TOWN OF CARMEL PLANNING BOARD

### **PLANNING BOARD AGENDA**

**JULY 12, 2017**

Re: 1923 US Route 6, Town of Carmel (the "Subject Property")

SHET C4.3 CONTECH DETAILS

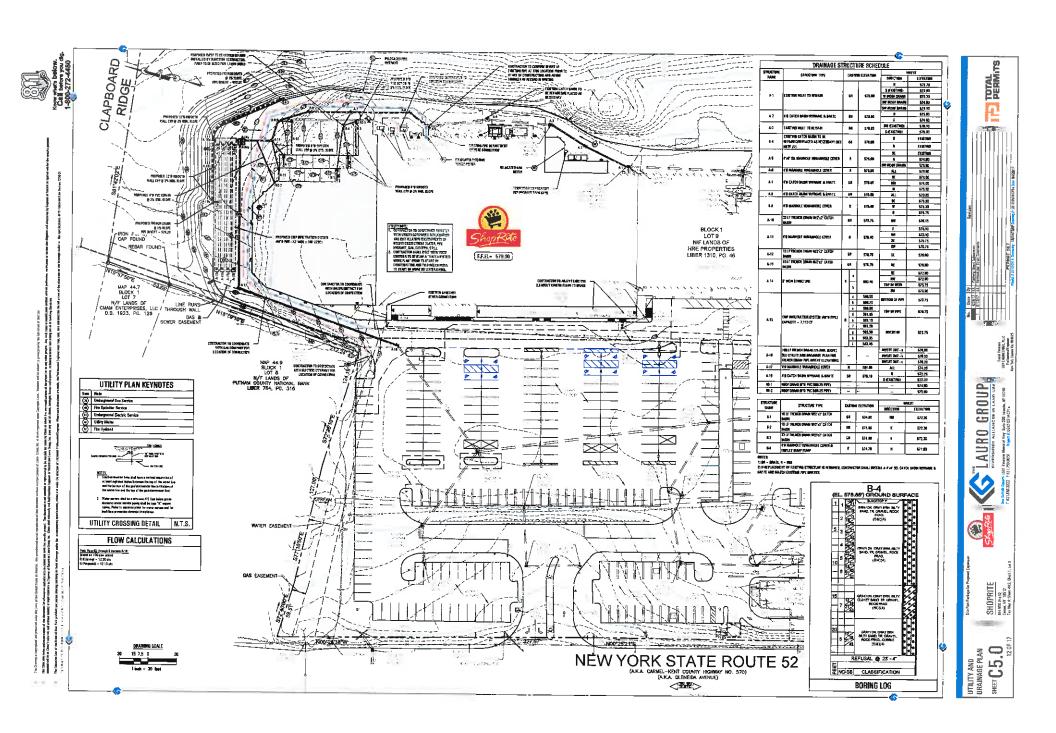
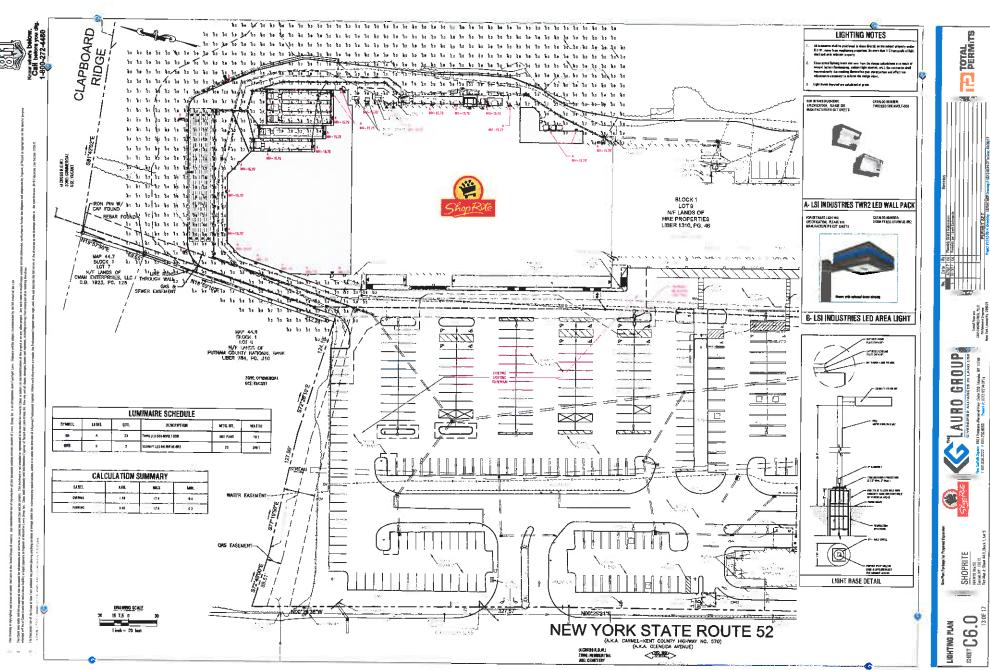
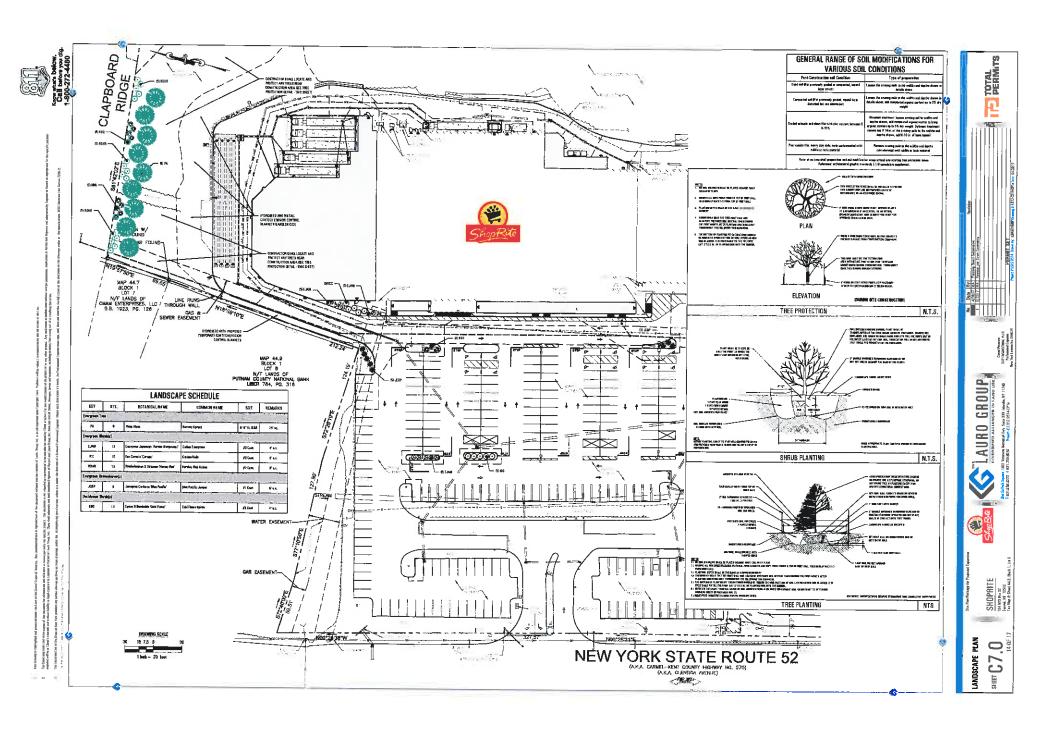
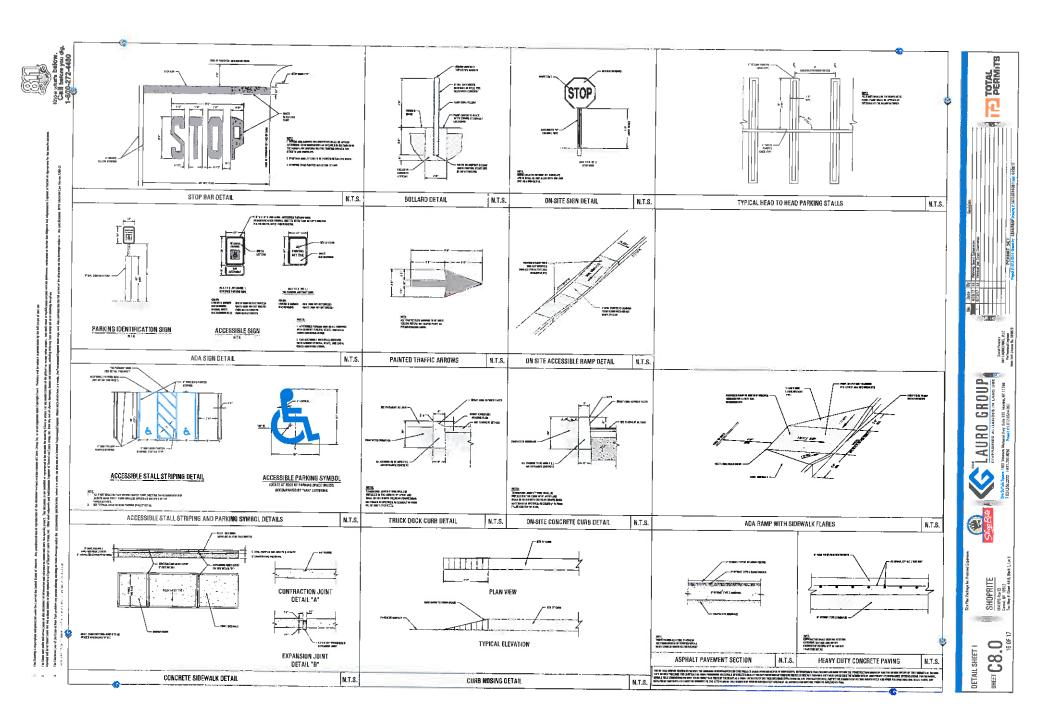
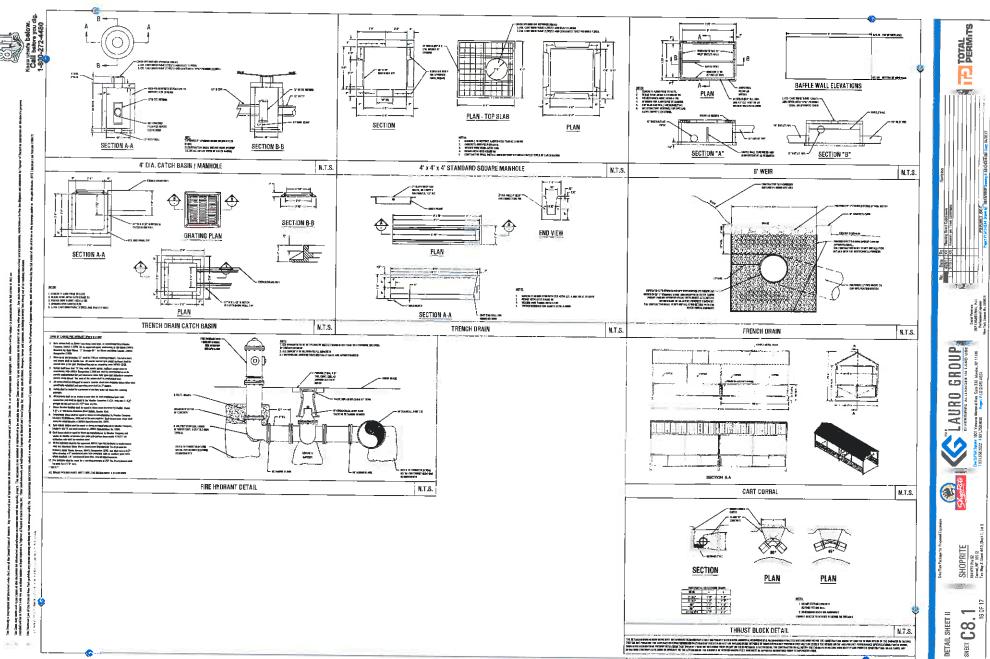
RESPONSE: The CMP Infiltration System detail and the drainage structure schedule has been revised to better note the use of "Perforated" CMP.
- 6. Provide greater detail on the construction of the Header Row for the storm water infiltration system.

RESPONSE: Additional specifications with greater detail are provided in the civil site plan package (sheet C4.3).
